Geotechnical Reports, Addenda, and LADBS Approval Letters

Geologic and Soils Engineering Exploration

1501 Marlay Drive

Response to City Correction Letter
1501 Marlay Drive
Lot 1, Tract 12204
Los Angeles, California

REVISED
APR 2016
DATE: AUG 2015
DRAWN: ACT
SCALE: 1"=8'
JOB: COLEMAN

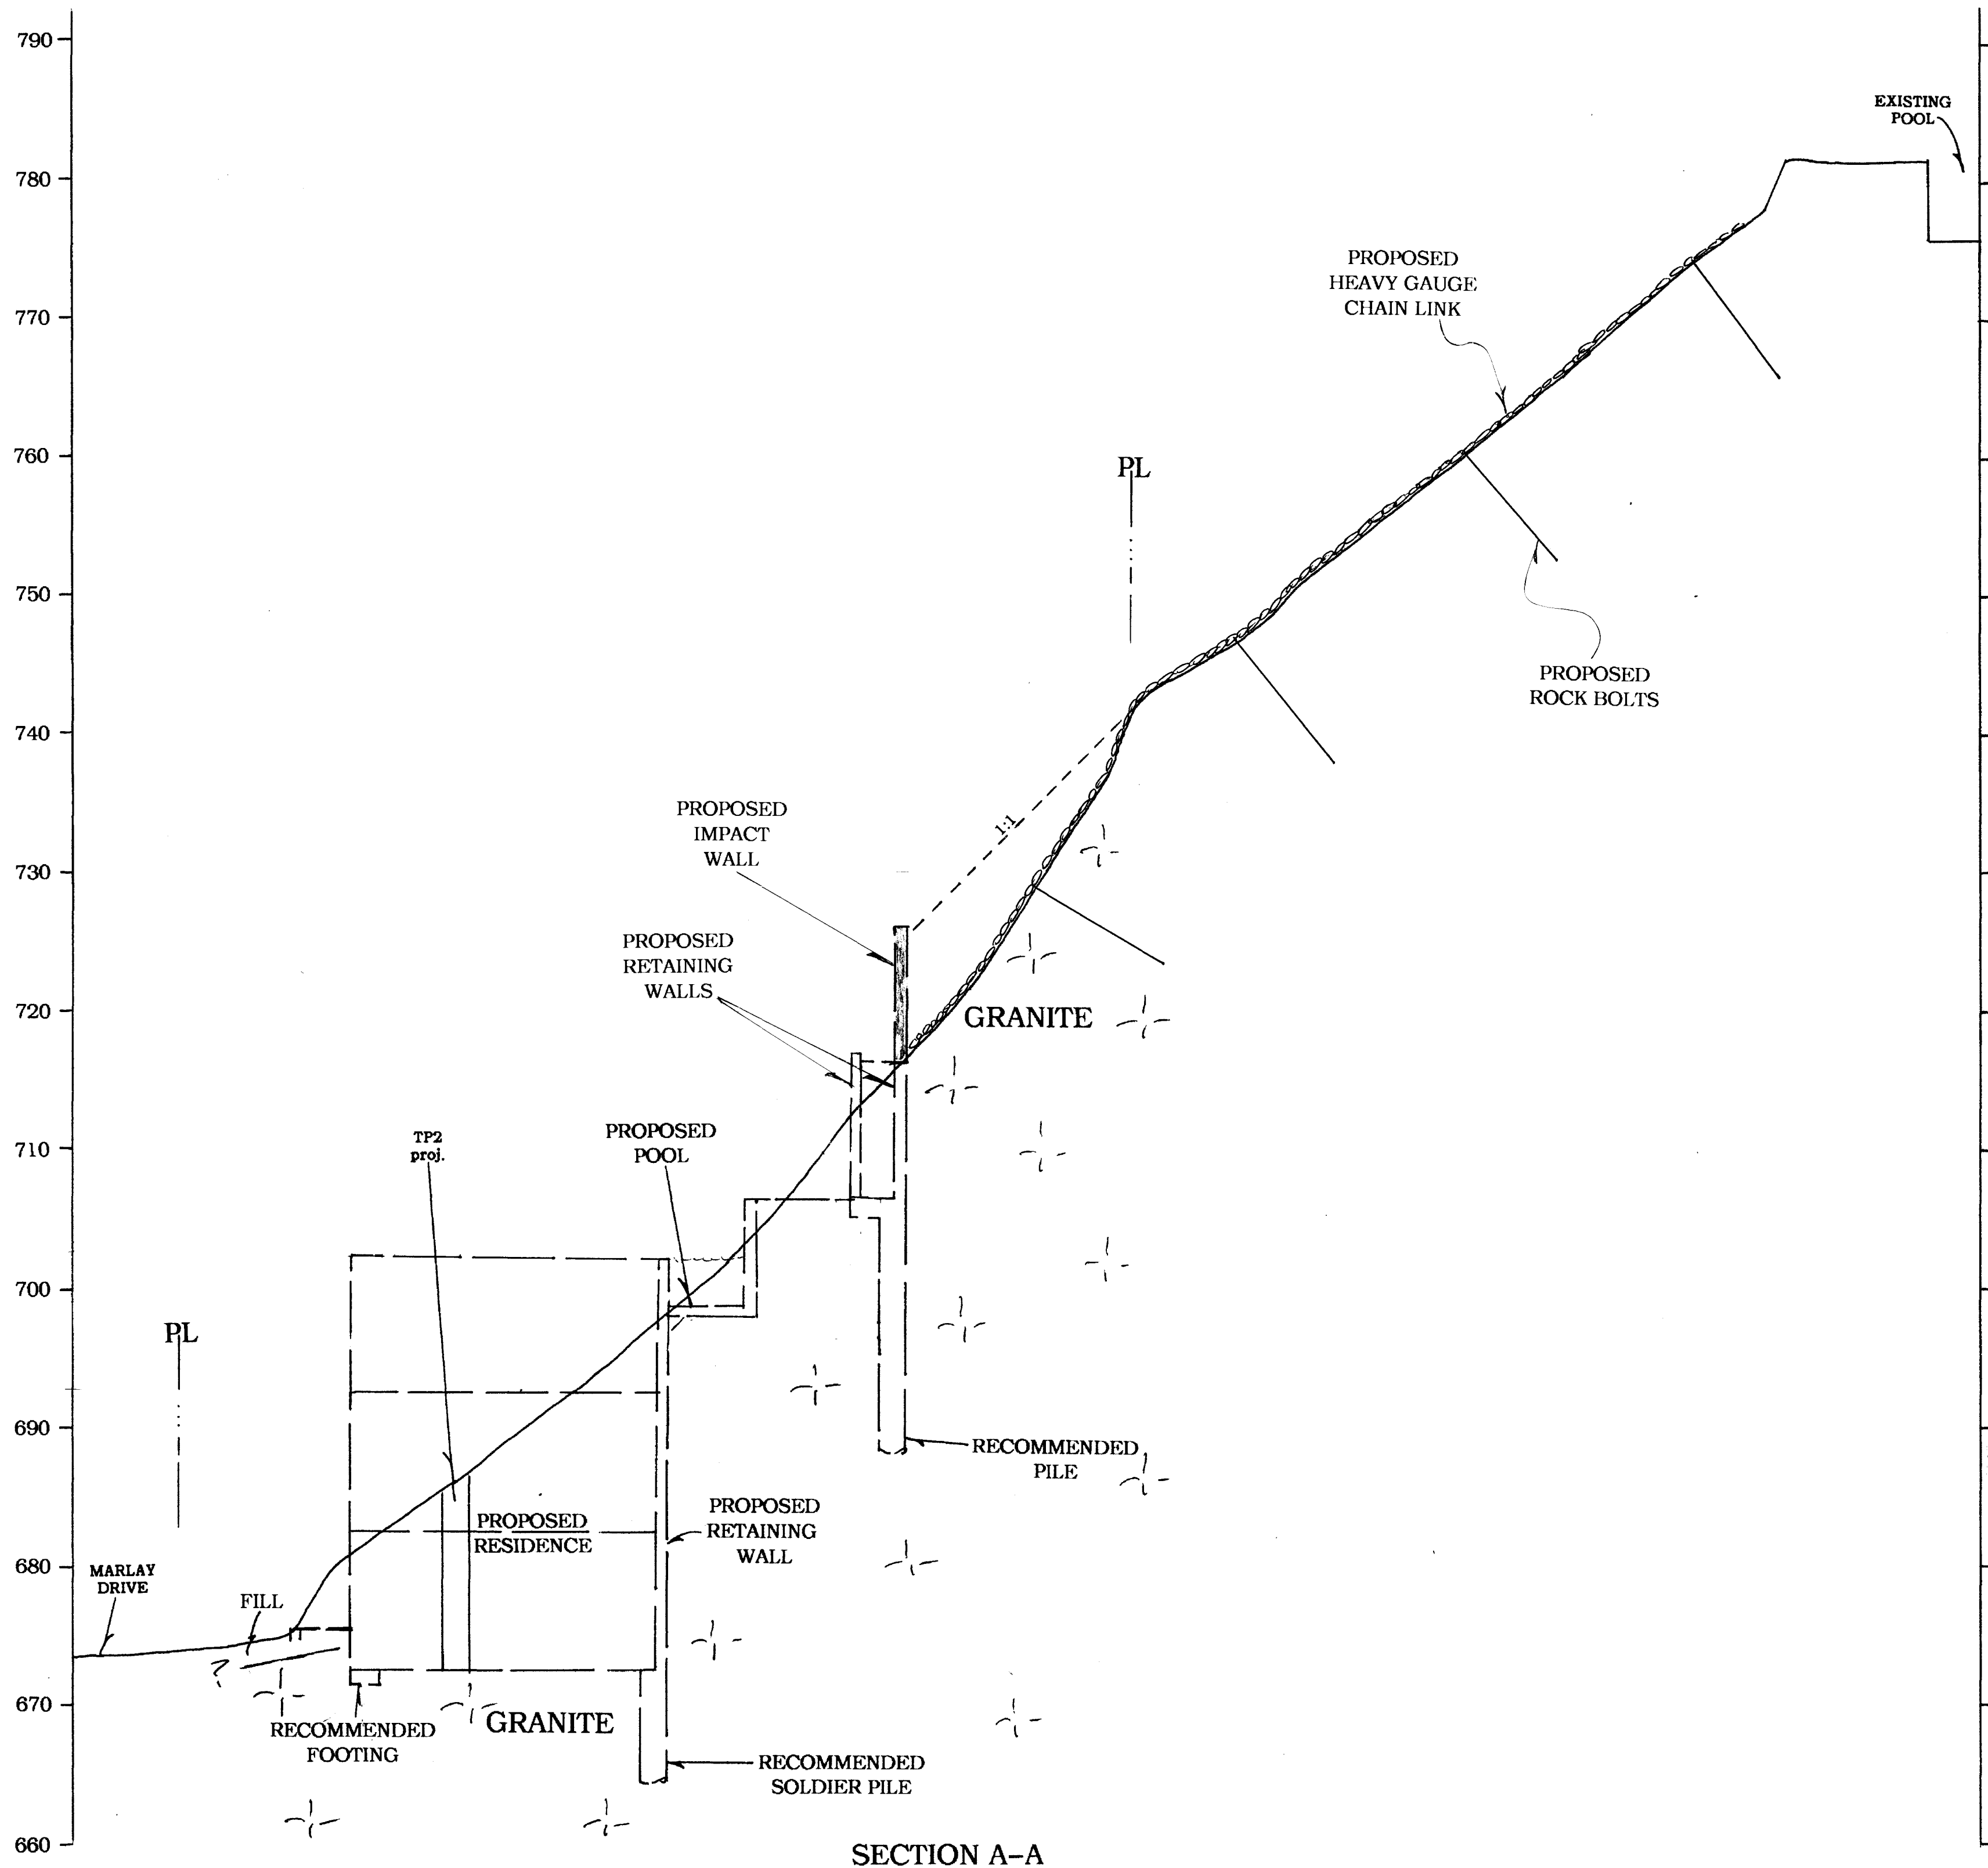
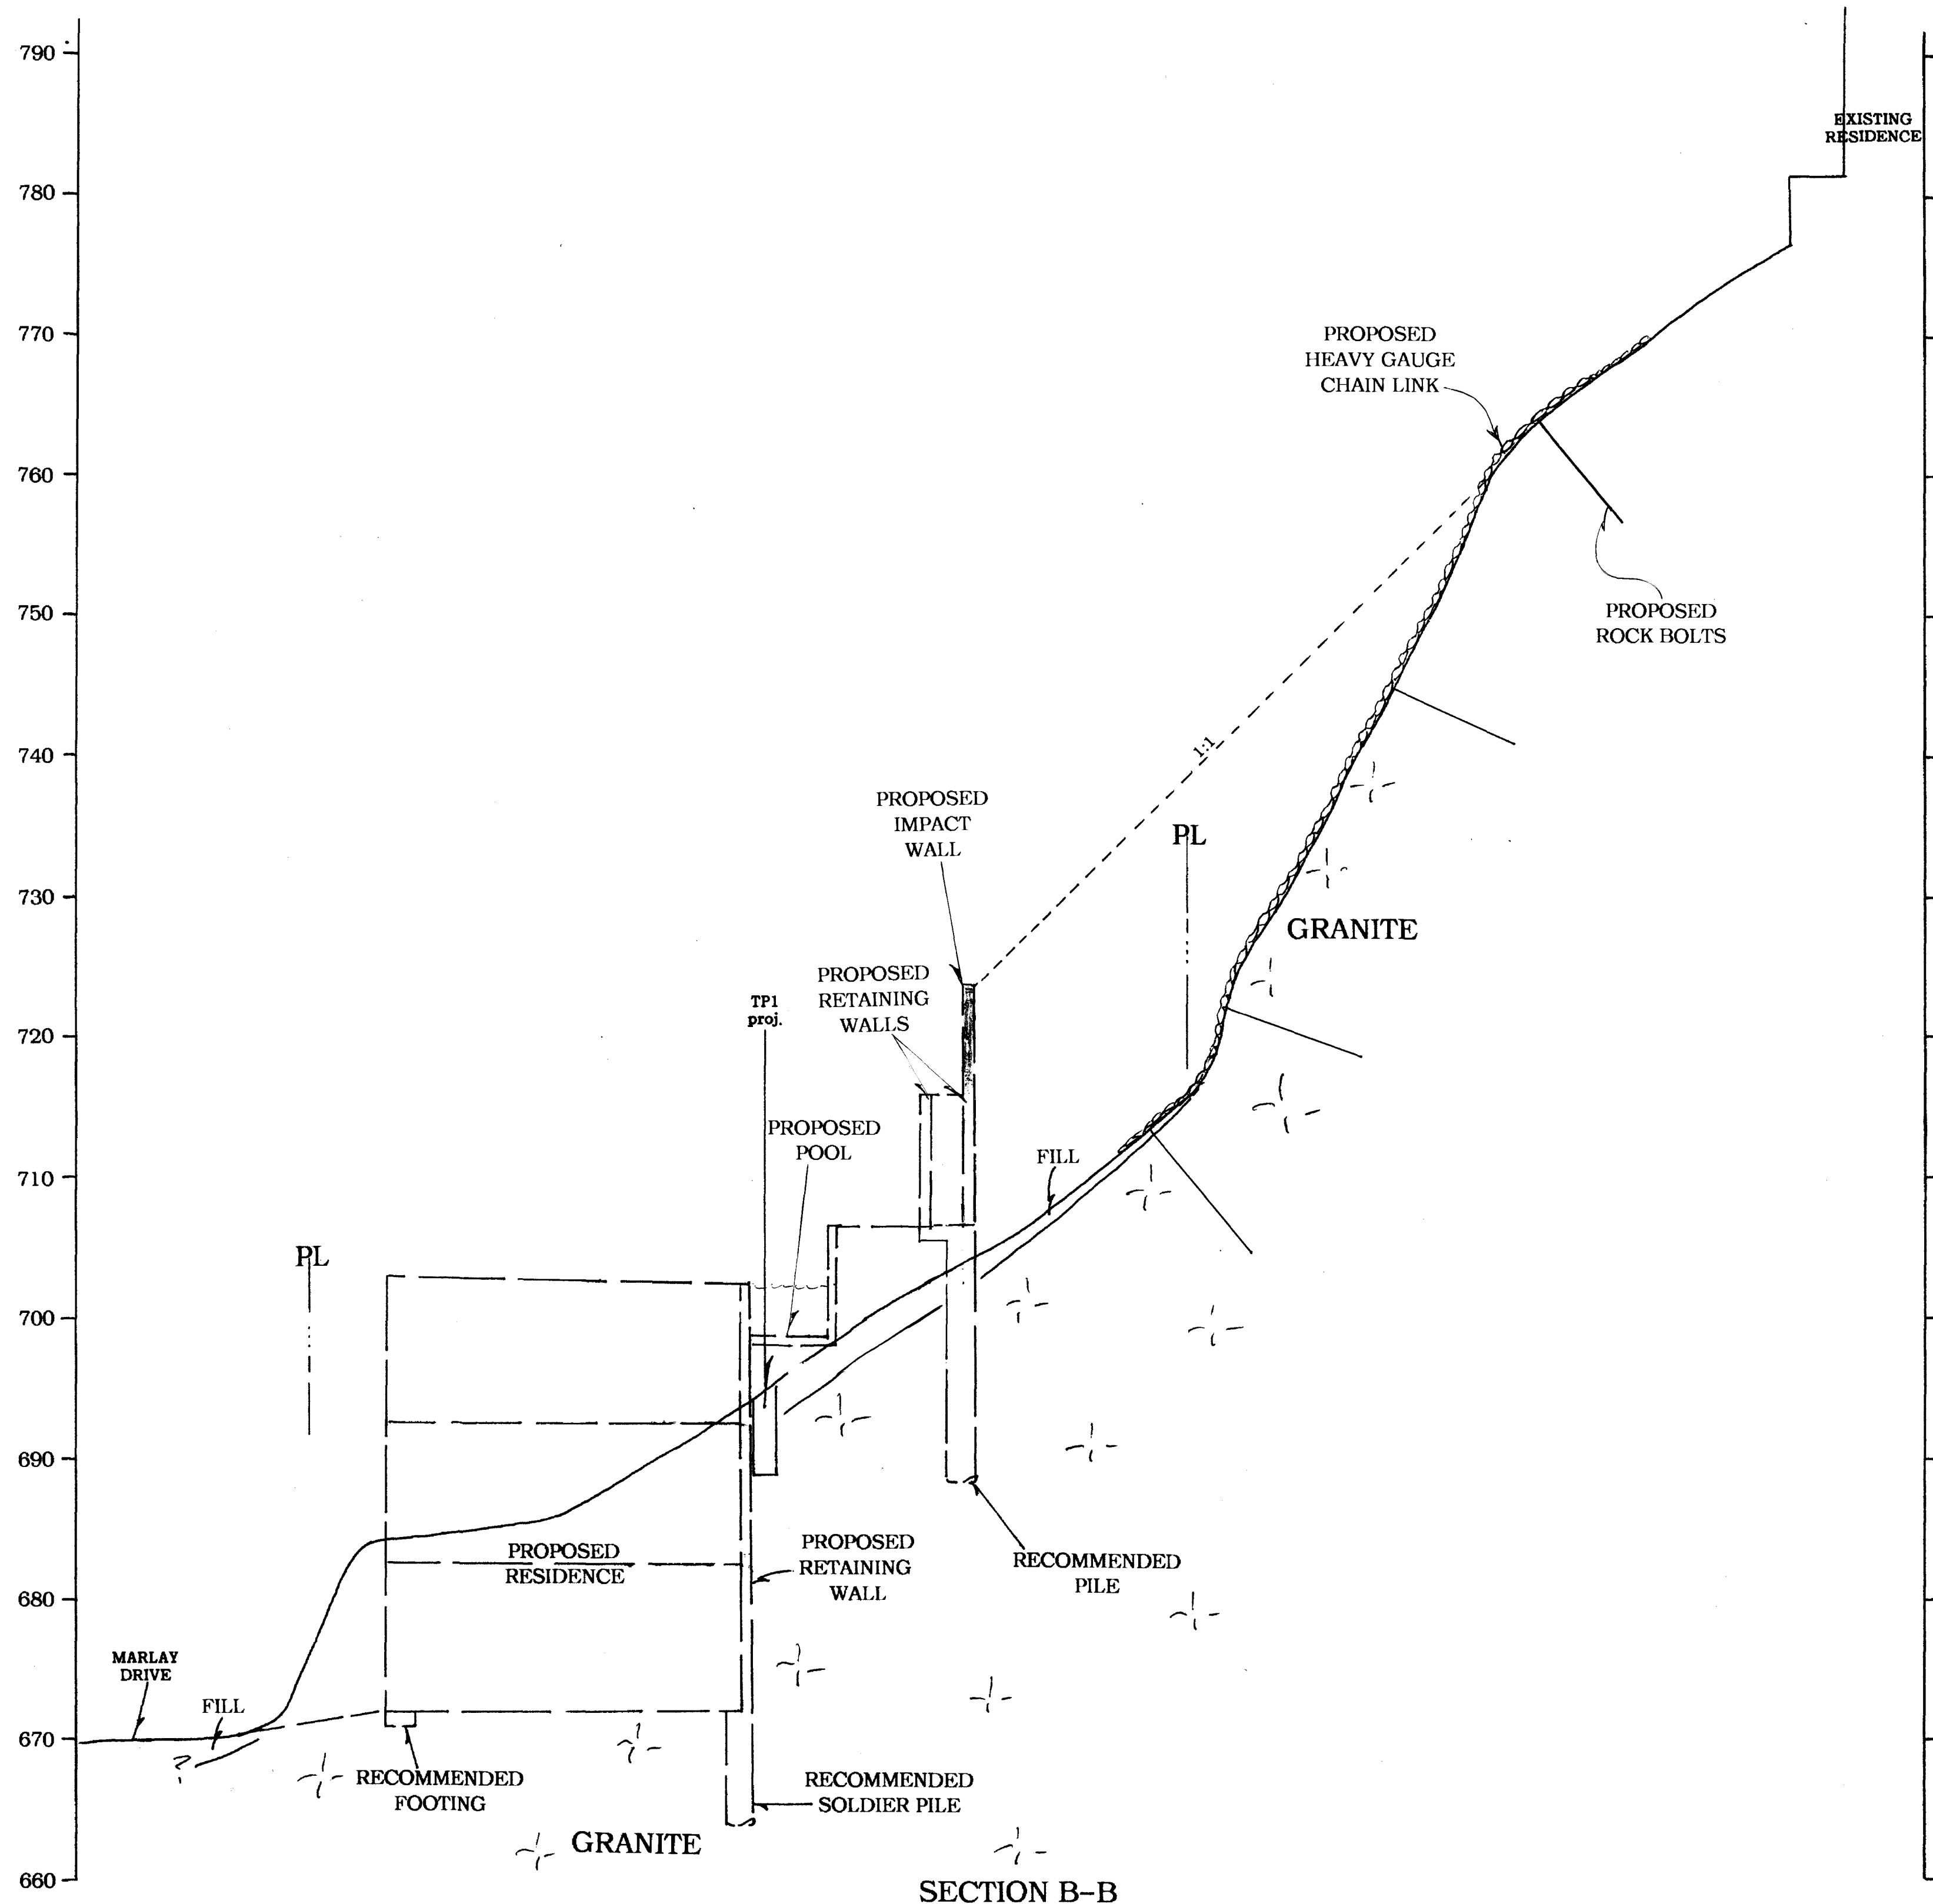
- c. Slope stability analysis of the potential failures using appropriate methods for type of failure identified from the kinematic analysis.
5. Verify the scale of the geologic map and indicate the correct scale on the map. Scaled measurements from the map do not correspond to the indicated map scale of 1" = 16'.

6. Show on the geologic map and legend the geologic units encountered on the site and show the geologic structure of the bedrock including joints and fractures for the kinematic analyses requested.

The scale for the previous Geologic Map and Section was provided by the architect. The revised Geologic Map and Section are presented at the corrected scale.
